**ADDENDUM NO. 3**  
**TO THE CONTRACT DOCUMENTS**  
**(PROJECT MANUAL, TECHNICAL SPECIFICATIONS AND DESIGN DRAWINGS)**  
**FOR THE**  
**ADMINISTRATION BUILDING IMPROVEMENTS PROJECT**  
**BID NO. 2023-BRAA-03**  
**BOCA RATON AIRPORT**  
**BOCA RATON, FLORIDA**

**April 21, 2023**

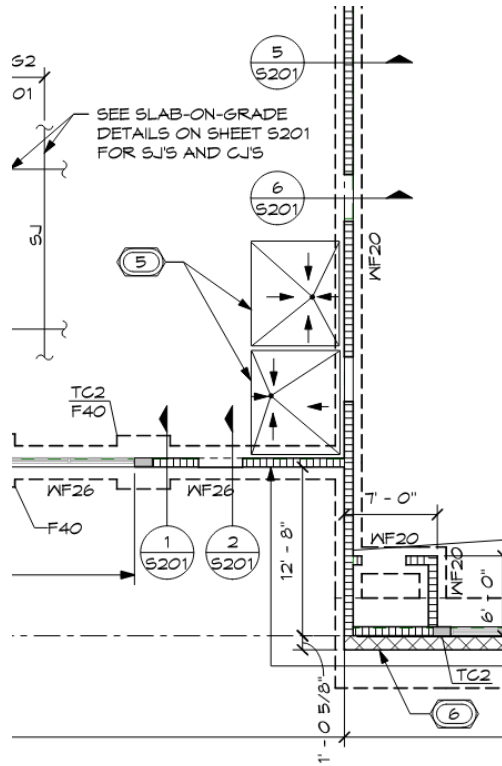
- 2.) Sheet A706 calls for a Hufcor partition system. Hufcor is no longer in business. Do you have a preferred alternate?

RESPONSE: Per Specification section 10 22 39 -2.2 "Folding Panel Partitions", the basis of design is "~~Series 820~~ (STC 52) Moduflex Model 410 MD by Panelfold, Inc. individual panels with offset stacking as indicated on floor plans or equal by one of the following:

1. Customfold, Inc.
2. Emco
3. FolDoor Operable Walls
4. ~~Huffcor~~
5. Kwik-Wall

Note final fabric finish selection to be confirmed by Owner and Architect from full range of manufacturer's fabric options.
